Report to Planning and Environment Committee

Subject: 2833257 Ontario Inc. (c/o Siv-ik Planning and Design Inc.)
955 Commissioners Road East
City File No. Z-9572 Ward: 14

Date: Public Participation Meeting
April 4, 2023

Figure 5. Conceptual Site Plan (February 2023)

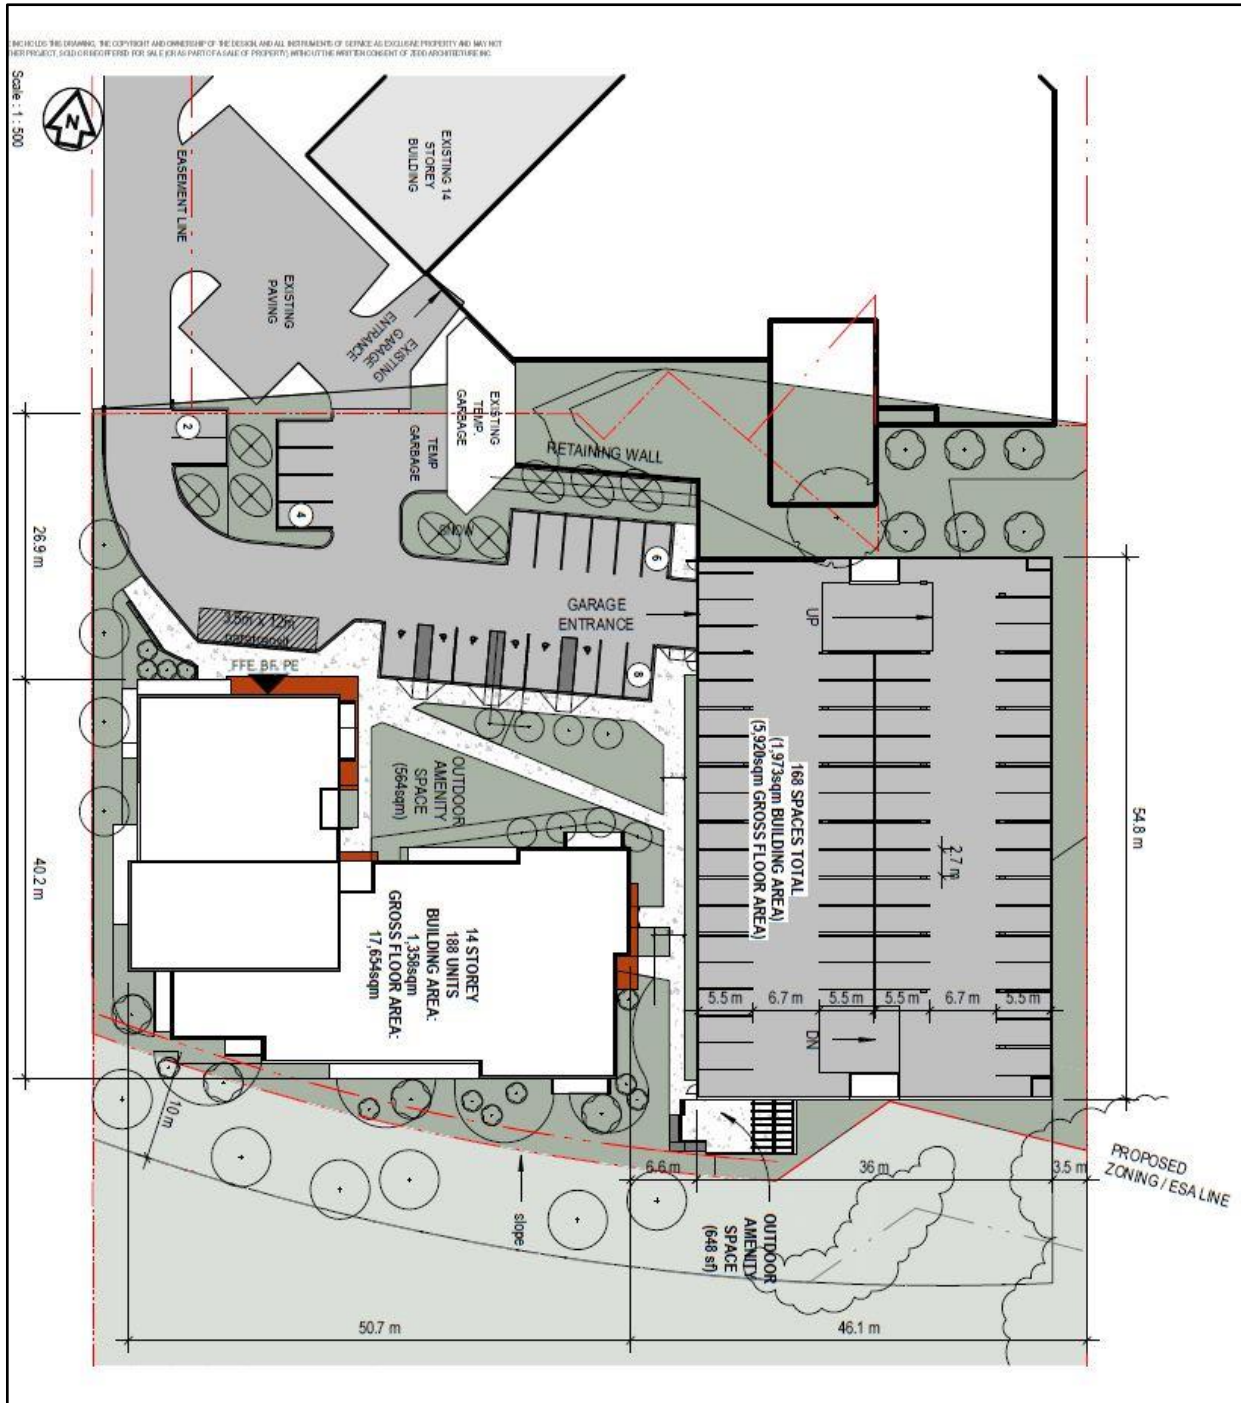
The proposed built form for the ZBA related to **955 Commissioners Road** must be revised to receive support from Urban Design. The following Urban Design comments must be addressed:

- 1) Parking for high-rise buildings should be provided underground or integrated into the building. Refer to the London Plan, Policy 273.
 - a. Reconfigure the site to be a more efficient use of the property and minimize the impact of the parking structure and provide more permeable green space. At a minimum partially integrate the structure into the building.
- 2) Provide an appropriate buffer between the parking garage structure and the southern border of the proposed built form.

- 3) Provide direct pedestrian connections from the city sidewalk and Caesar Park to the proposed built form. Refer to the London Plan, Policy 255.
 - a. Work with the Parks Department to assess the feasibility of formalizing a pedestrian connection from the entrance of the proposed built form through Caesar Park to Commissioners Road.

- 4) As a high-rise development, reduce the impacts of the large floor plates by incorporating setbacks, step-backs, and a podium into the massing. Maximum floor plate sizes are typically 1000 square meters. Refer to the London Plan, Policy 292.

Comment:
The panel suggests that further analysis take place regarding the orientation of the tower. Consider orientating the tower East-West rather than North-South. This will create views for residents of the existing tower to the North and future residents of this development. It will also allow for potential future intensification on site at the location of the proposed parking garage. If the current tower configuration remains, consider offsetting the tower floorplate from the West above the 7th floor to differentiate the volumes and create a contiguous 7 storey expression.
Applicant Response:
The proposed building orientation and massing strategy has been significantly informed by the surrounding context and functional requirements of the site. The current placement and orientation of the building optimizes opportunities for integration with the existing circulation network, provides for significant tower separation from the existing phase of development, allows for strategic placement of the parking garage on the east edge of the site where it can leverage the natural topography and respects the 10m environmental setback/buffer.

Comment:
The Panel notes that the North side of the site places undue priority on surface parking and vehicular circulation. Consider expanding the current parking deck to accommodate the surface parking stalls and giving this area to the outdoor amenity.
Applicant Response:
The project team supports reducing the amount of paved surface, where possible and has sought to minimize the at-grade space devoted to vehicle circulation while still maintain the required functional elements for the development. The current surface parking is preferred in this design, as it allows for barrier-free access to the accessible parking spaces. It also allows separates the visitor parking spaces from the resident spaces inside the parking structure. This separation provides the opportunity for the installation of security measures (gates or locked doors) on the parking structure if needed. We will examine alternatives for vehicular circulation however, we believe the current design will be the least impactful for garbage pick-up and it connects seamlessly with the existing driveways at 951 Commissioners Road East.

Comment:
The panel notes that the Garbage Room and Bike Storage Room are currently located in prominent locations on the ground floor. Consider relocating these functions to the east end of the building and relocate the displaced two-bedroom units to the Bike Storage Room and services adjacent to the main lobby. This will provide the residents with a view to the open green space to the West.
Applicant Response:
Zedd Architecture has prepared an updated conceptual design package for the project dated October 25, 2022. A revised ground floor plan is included in the package. The garbage room

The panel notes a considerable distance exists between the primary residential entrance and the parking structure and recommends an additional entrance be provided along the east wing of the building to improve walkability. Consider shifting the exit stair at this location further east to provide an entrance from the North with adequate lobby space and glazing to the forecourt.

The panel notes that the landscape plan does not match the architectural site plan. The North-East corner of the building illustrates discrepancies in the layout of the pedestrian walkway. The panel notes that further programming and detailing of outdoor amenity spaces should be provided.

Zedd Architecture has prepared an updated conceptual design package for the project dated October 25, 2022. A revised ground floor plan is included in the package. The secondary entrance has been shifted to the east side of the building to provide a shorter route/more direct pedestrian access to the interior of the building from the parking garage.

Acknowledged, thank you. We will work closely with the architect and landscape architect for this project to ensure that the plans match for the Site Plan Application submission. We will work with the landscape architect to come up with programming and detailing of the outdoor amenity space.

Figure 10. Image Depicting the 10-Metre Buffer From the ESA

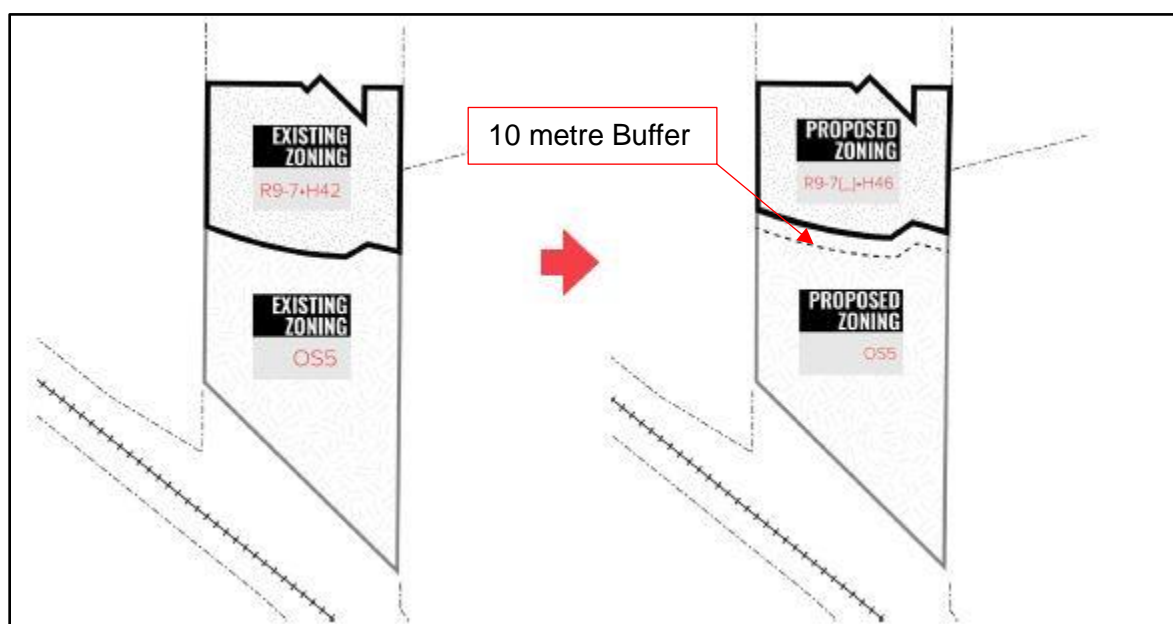
- At this time of the ZBA application, the only ecological requirement is that the buffer shall be zoned to OS5. This appears to be shown in the development proposal by the “Proposed Zoning/ESA Line”, however it is not currently clear in the concept plan or the requested zoning in the application that the buffer will be rezoned to OS5.
- Opportunities for the City to acquire the southern portion of the subject lands zoned OS5 and within the ESA should be explored. These lands would likely not be developable in the future and would strengthen linkages within the Natural Heritage System.
